Re: Proposed Industrial Warehouse Expansion: 6622 Bank Street
CAMM Machinery Movers
Technical Memorandum (Our Project 7329)

Attachment A: Site Plan Concept

Attachment B: Turning Movement Diagrams

Attachment C: City Staff Correspondence

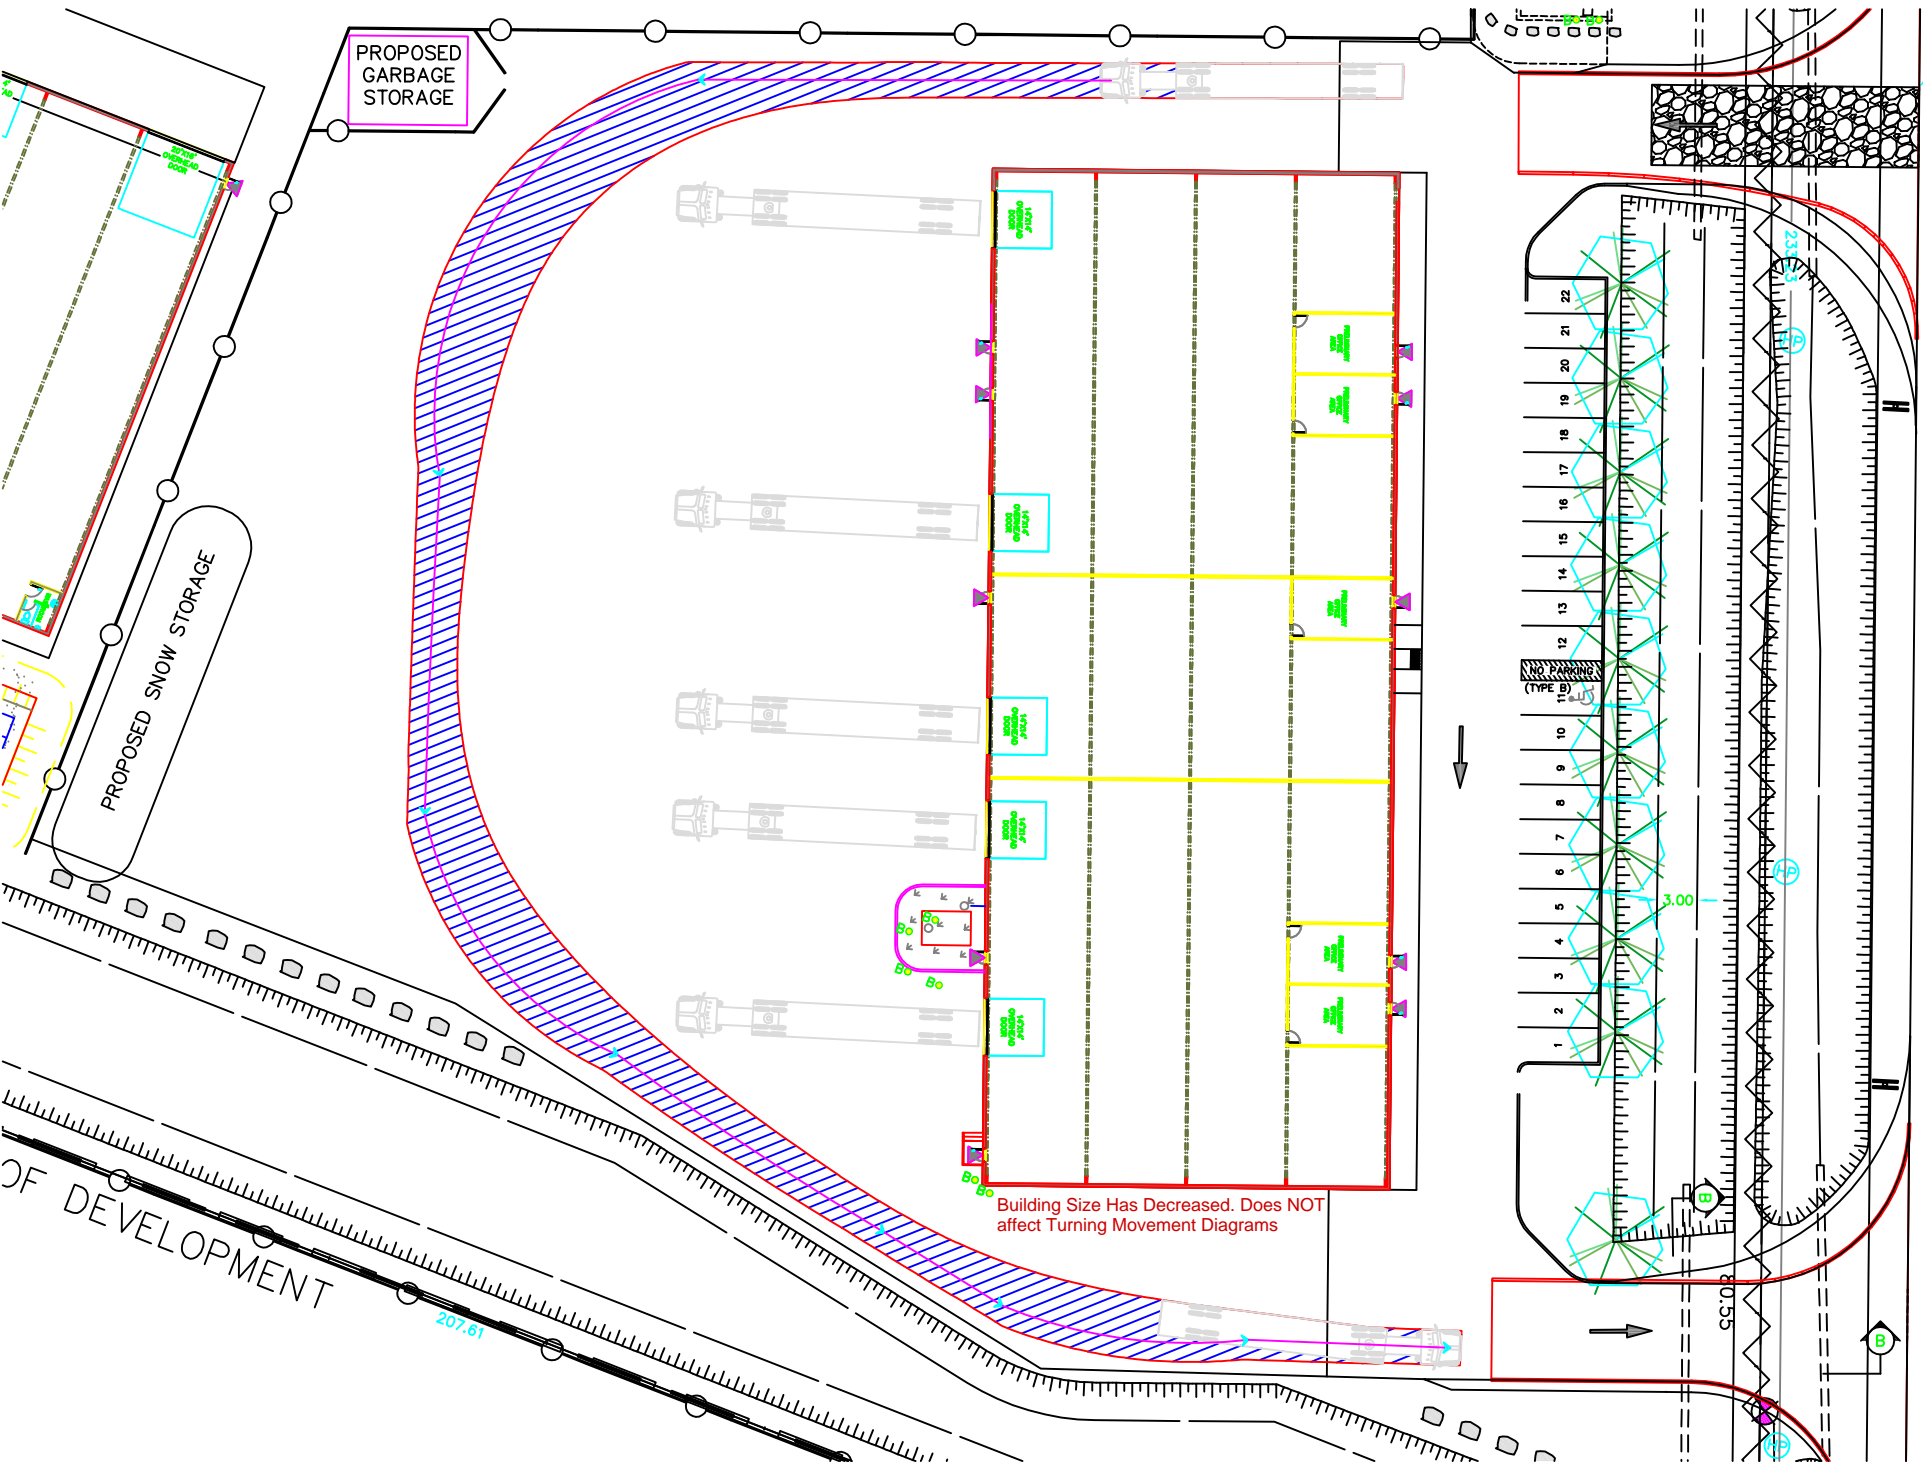
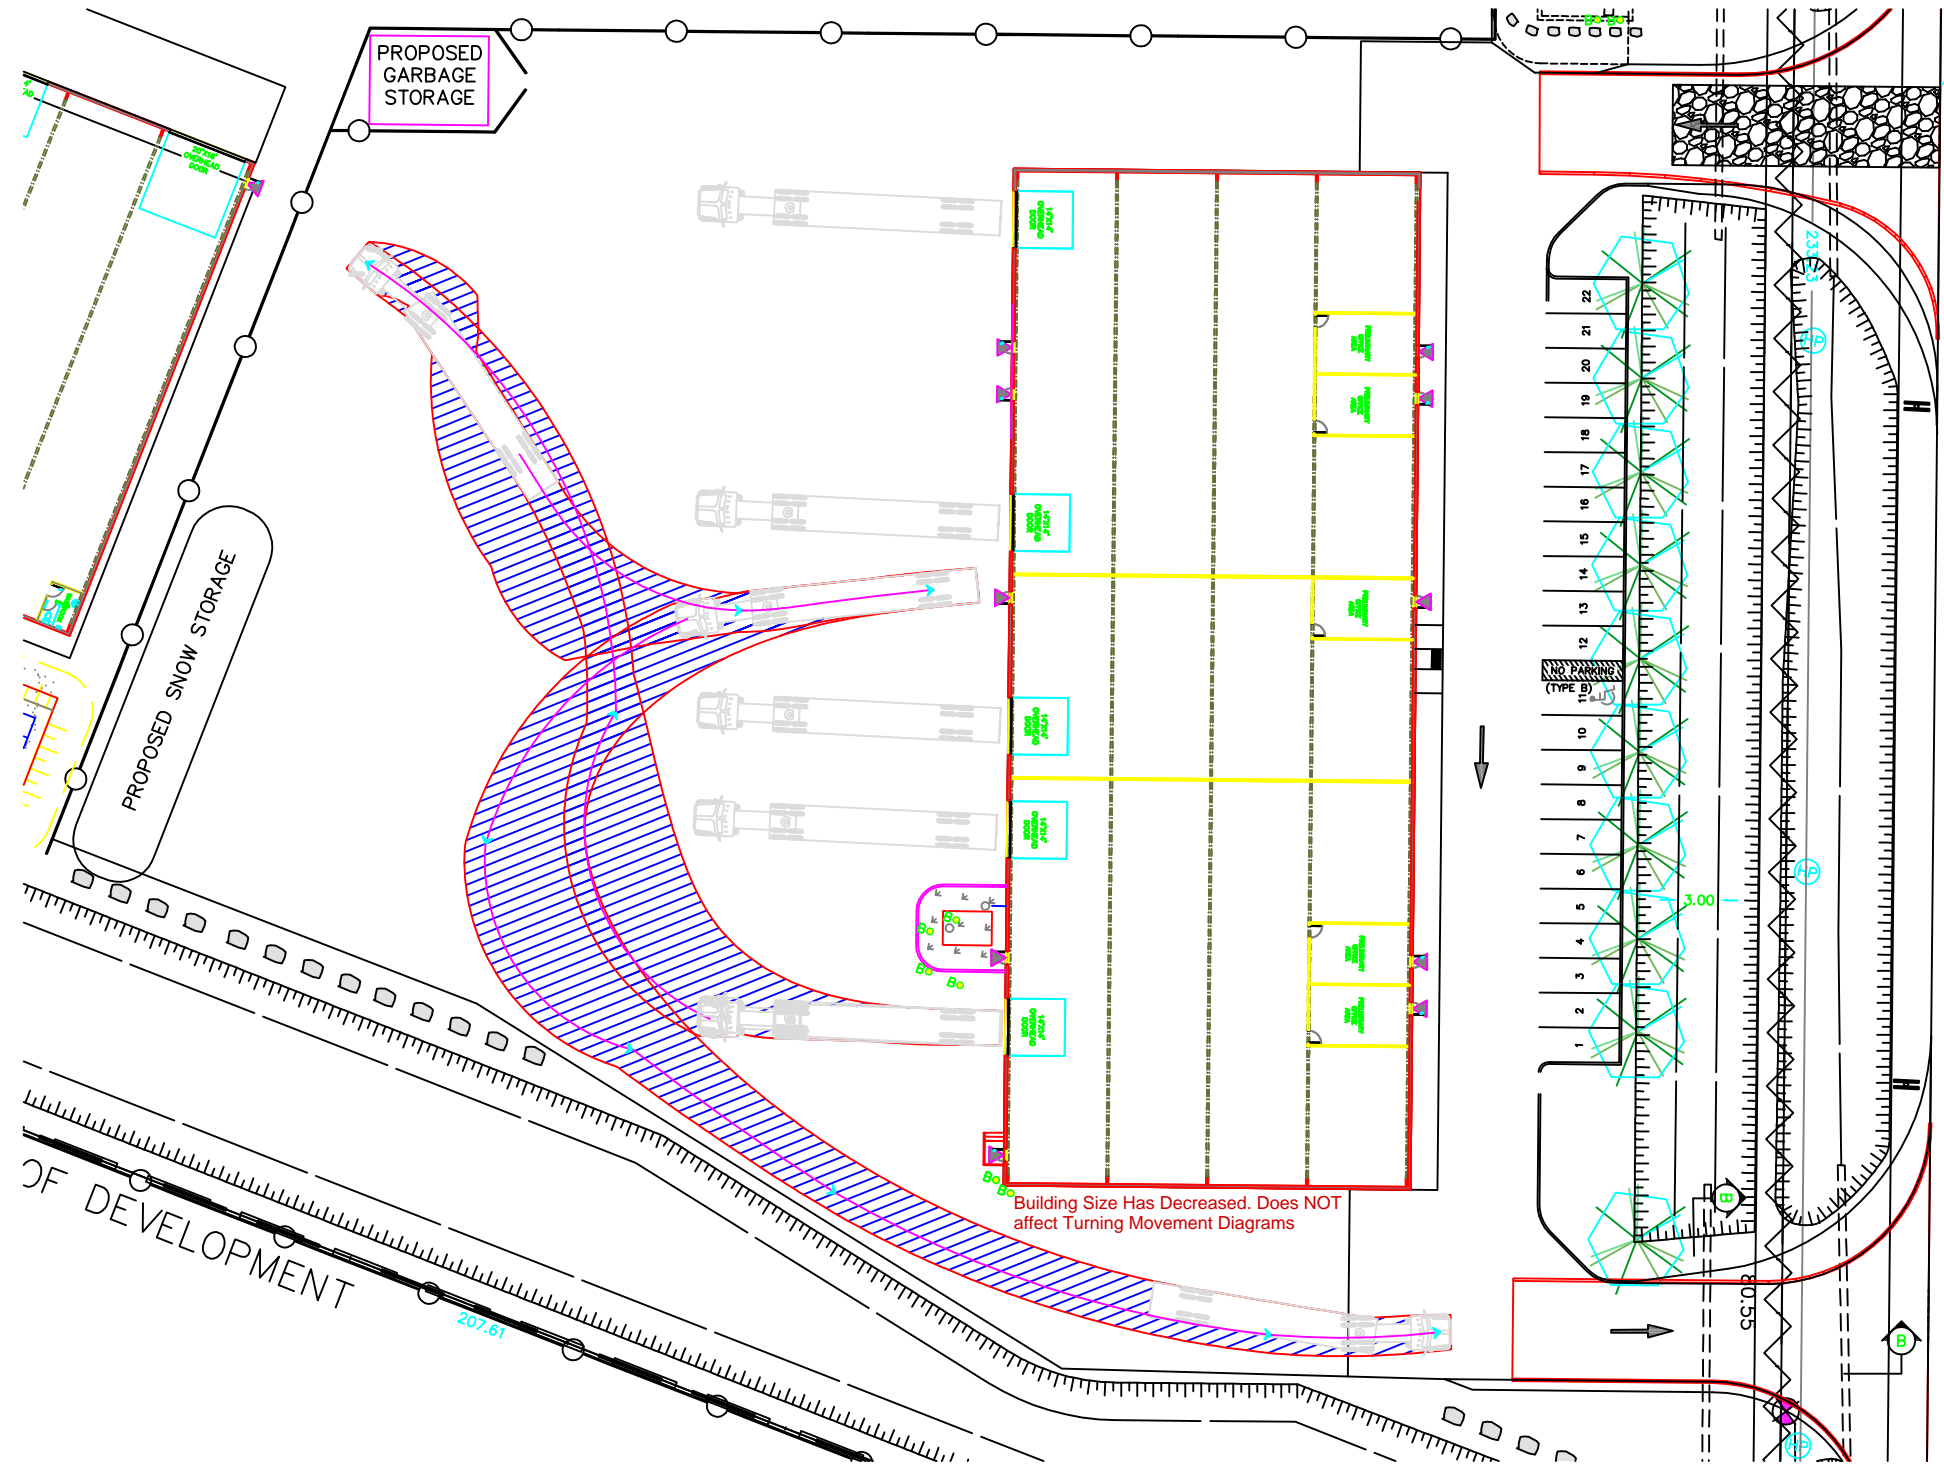
Building Size Has Decreased. Does NOT affect Turning Movement Diagrams

Building Size Has Decreased. Does NOT affect Turning Movement Diagrams

LAYOUT PLAN

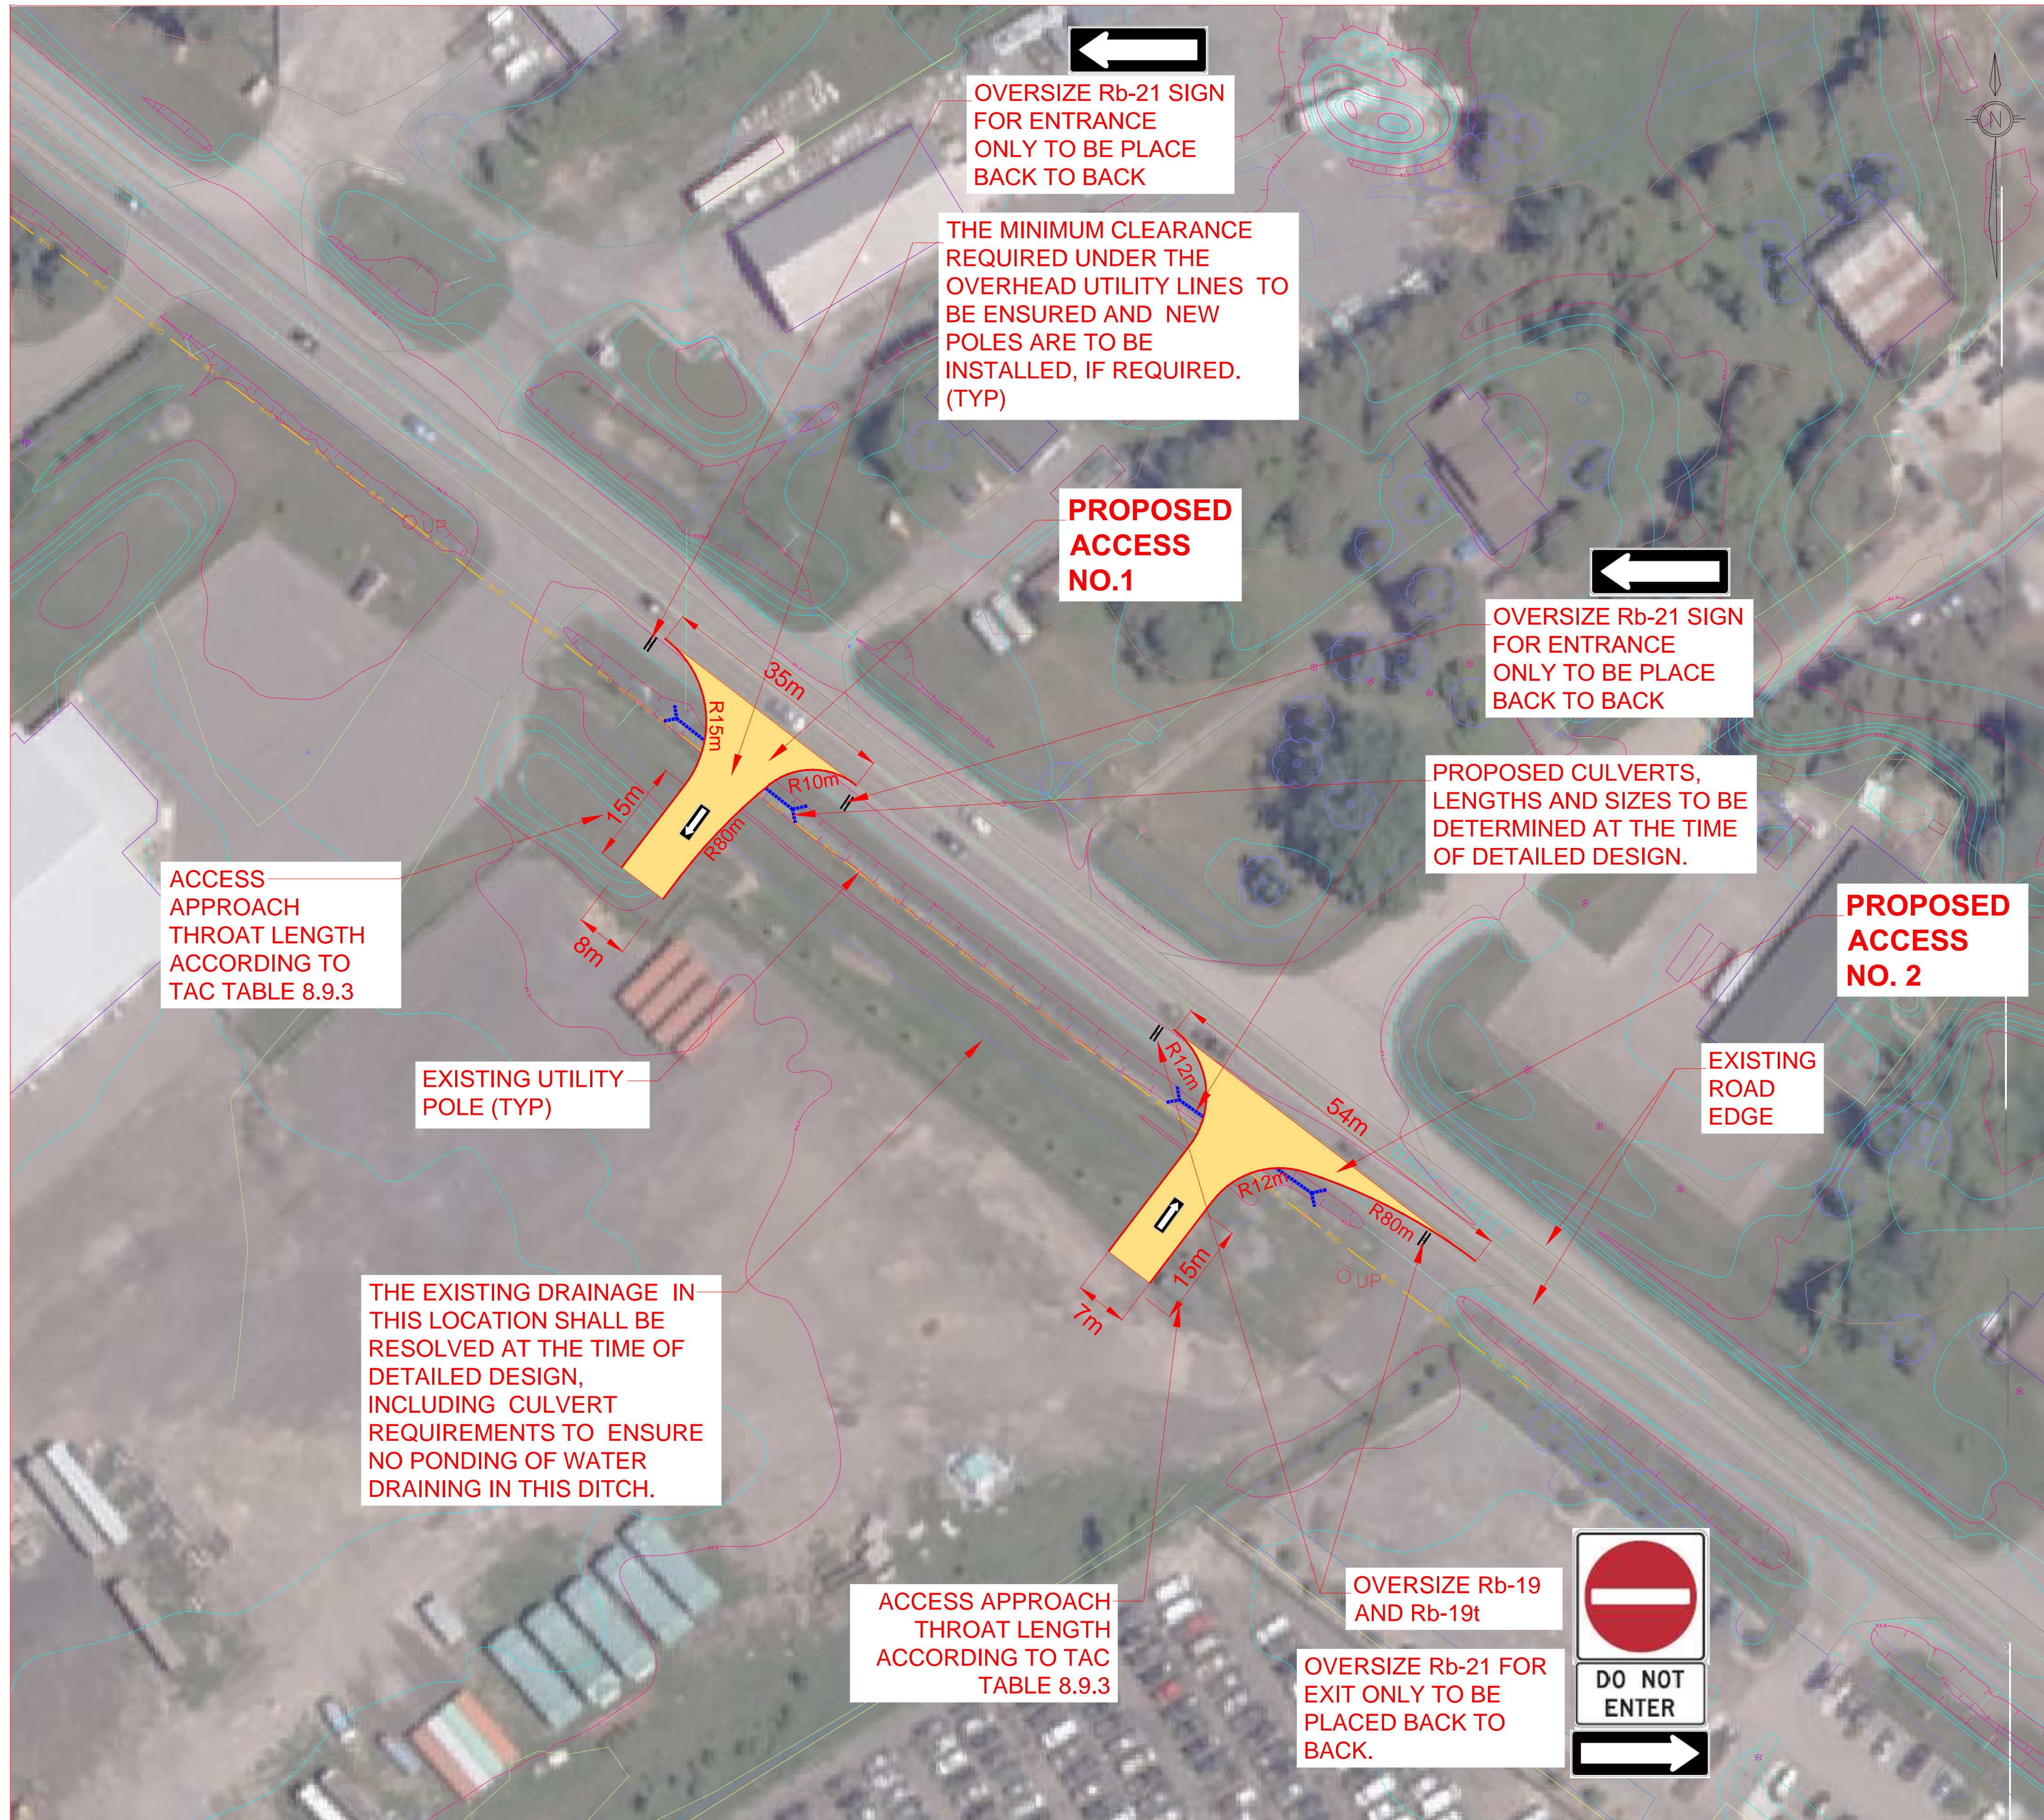
Our issue is compliance with TAC Geometric Design Guideline regarding the required “throat length”.

- This development falls within a light industrial land use which is under 10,000 m² abutting an arterial road.
- As such, the minimum required clear throat length would be 15 meters (Pls see attached Figure 8.5.2, TAC Geometric Design Guide).
- The 15m storage distance is illustrated on the plan in cyan.
- We tightened up the radii of the access designs as much as possible to assure the entry of WB-20 vehicles
- When the access designs were overlaid onto the site plan, the required 15 meters throat length could **not** provided.

1. The accesses are both one-way operation only. Normally, throat length requirements are based upon 2-way operation and the required storage distance to accommodate a heavy truck (WB-20s) is detailed to assure that there would be no spillover onto the major roadway. We believe that the access into the site provides more than sufficient storage length to queue behind a passenger vehicle entering the front parking lot.

2. Since all of the heavy trucks (WB-20s) will be proceeding straight to the back of the building, and not turning into or using the parking lot located at the front of the building. This means there would be a very low probability of queueing caused by consecutive heavy vehicles arriving at the same time.

3. The development is expected to generate “very” low traffic volumes, so we believe there will be no issues with regard to queuing or blocking traffic on the Bank Street corridor; and

4. Traffic leaving the site by way of the one-way south egress that turn right or left onto Bank Street have more than enough storage space.

In short, we would appreciate your comments on the access design as presented.

The throat length provided is adequate.
